工程指示 / 要求簡箋(E.I.)

工程指示編號：EI / 0748 / 19 修改版次：
工程編號：J-836 工程名稱：日出康城 7 期 平台
工程項目：WINDOW WALL (WW1) 鐵件生產 ROOF
收件人：Maggie 發件人：大明 日期：25/06/2019

250x150x16mm 扁通切割成 60x150x60x16mm 鐵槽

构件: 1B2a-12

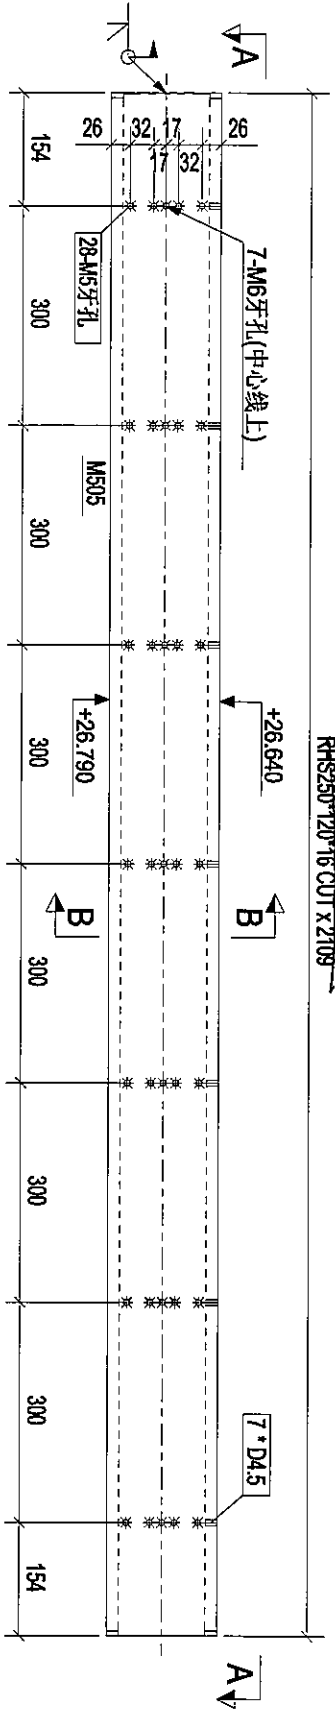
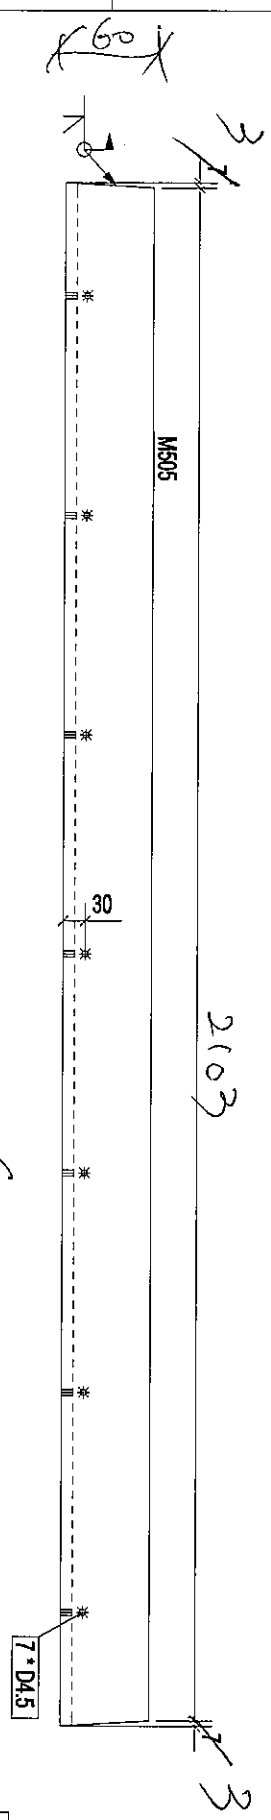
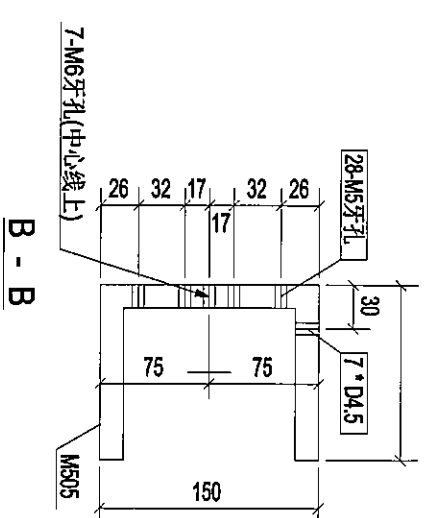
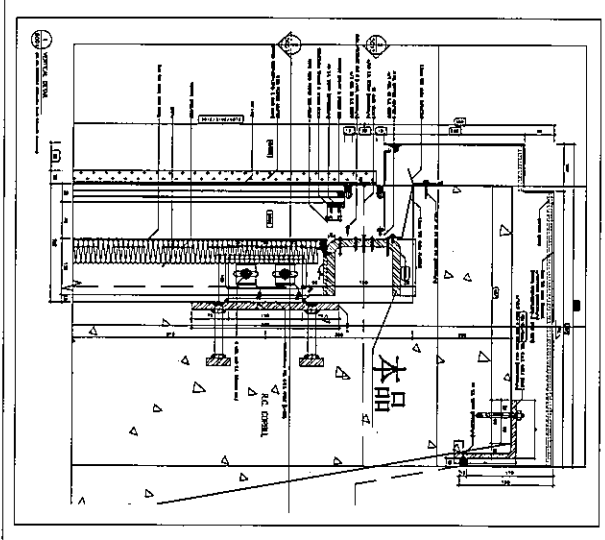
50x150x60x16mm C45AN/C (L=2109) 说明: 因增加 $\phi 4.5$ 孔而变出来的新编号。 (12)

| [1B2a-15] | | | |

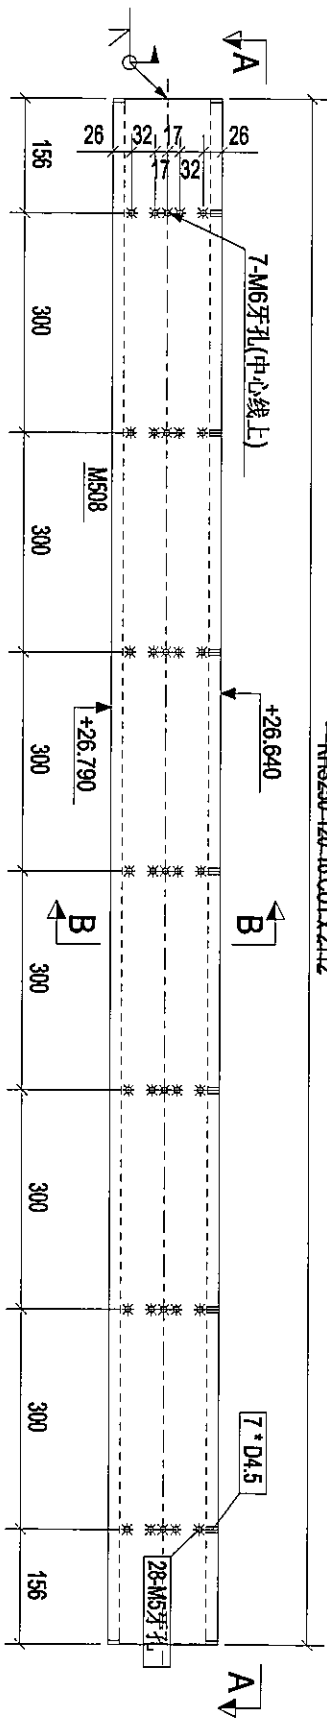
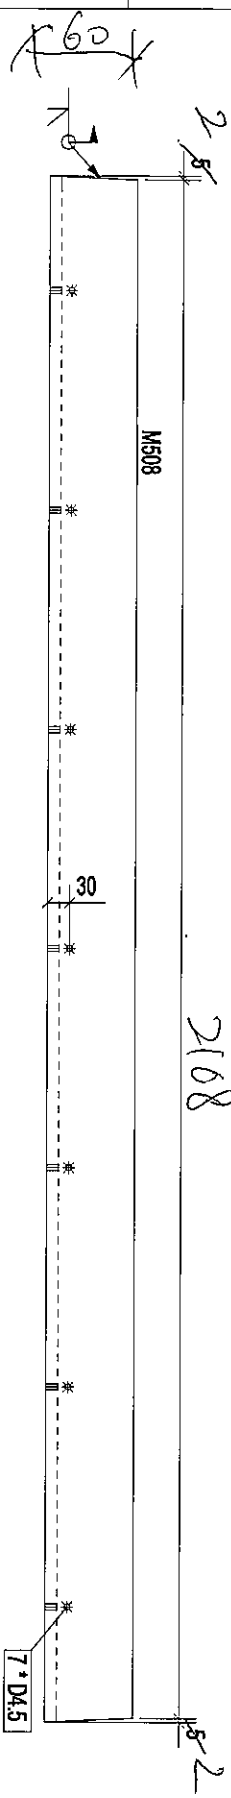
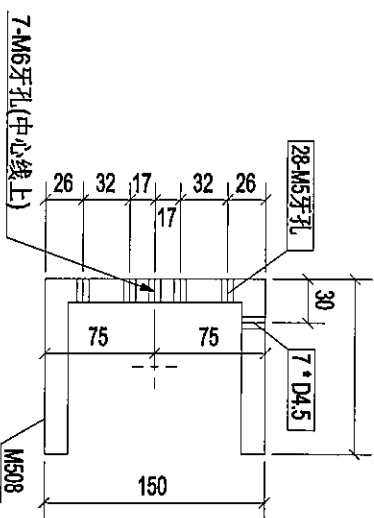
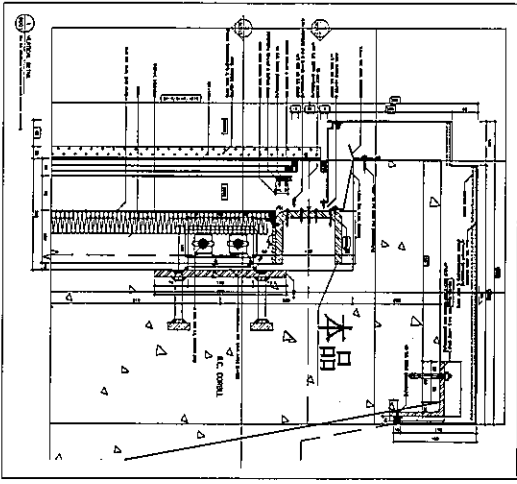
60x150x60x16mm C CHANNEL (L=2112) 说明: 因增加Φ4.5孔而变出来的新编号。

ELEVATION 1 OF WINDOW WALL 1

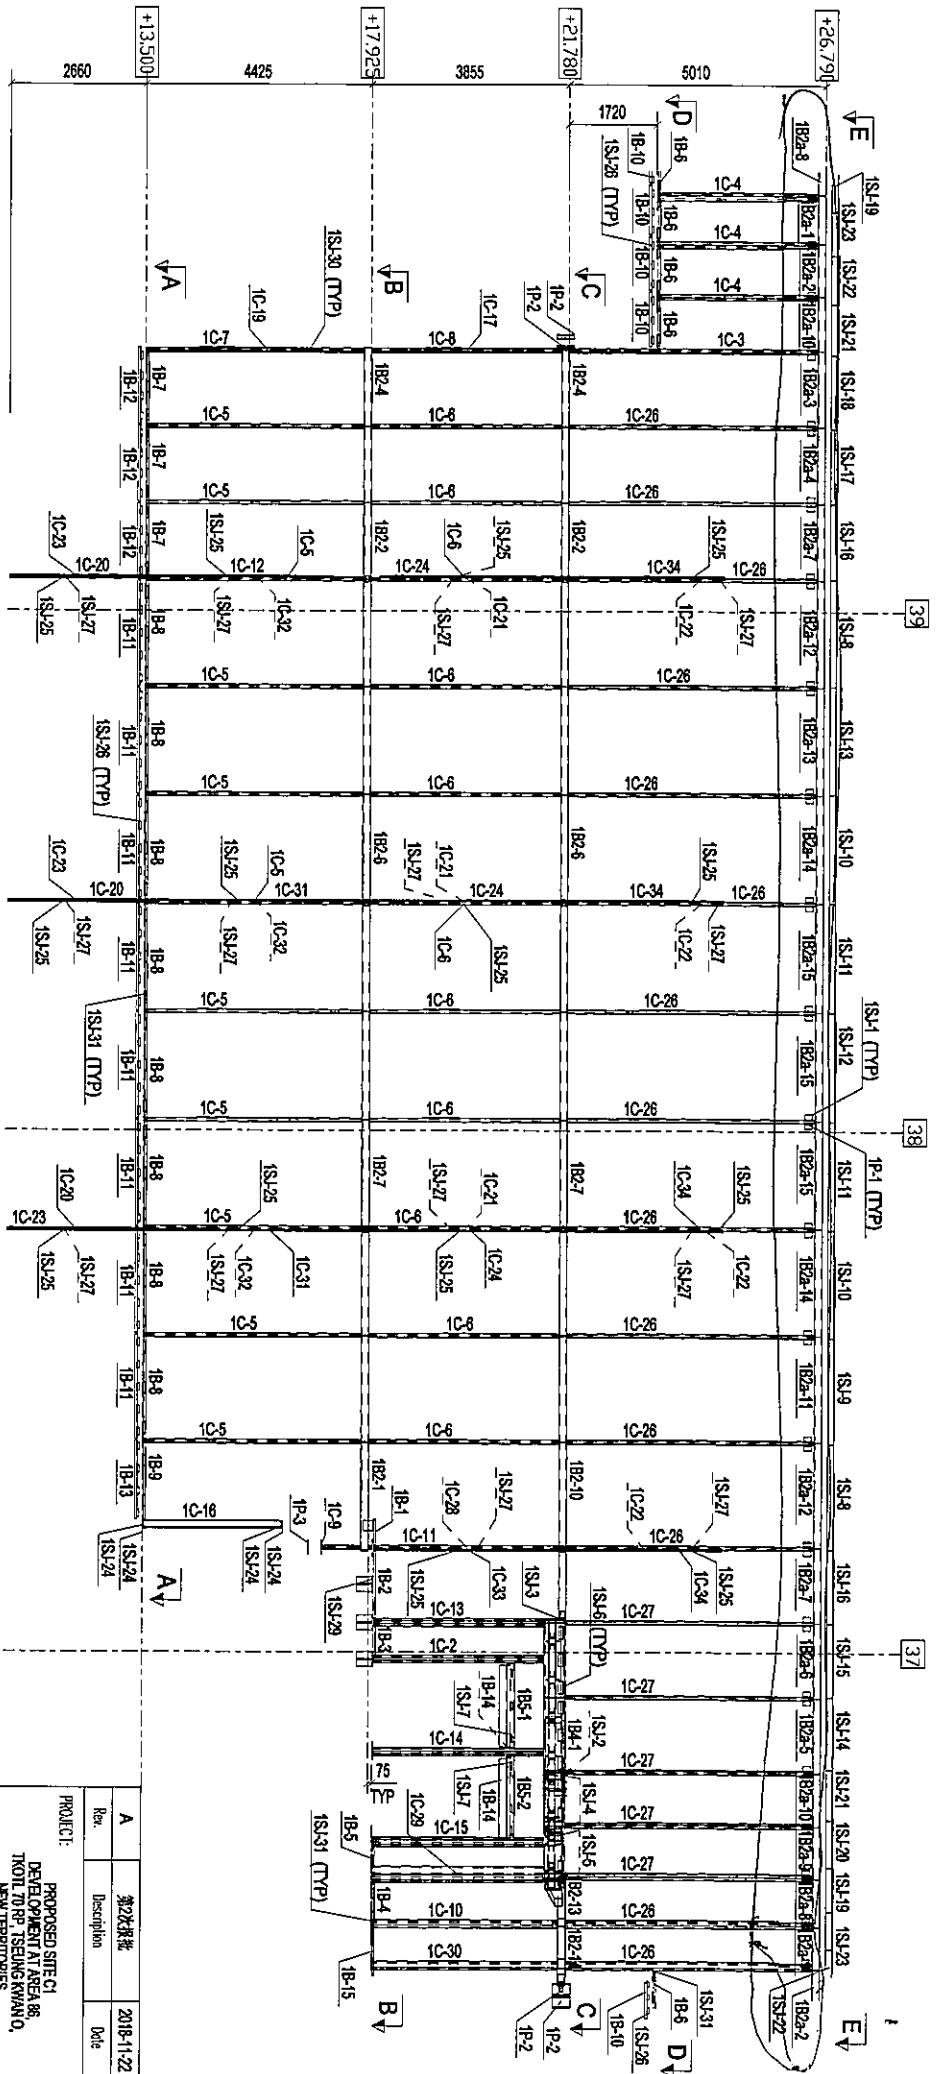
说明：修改导致部分编号改变。
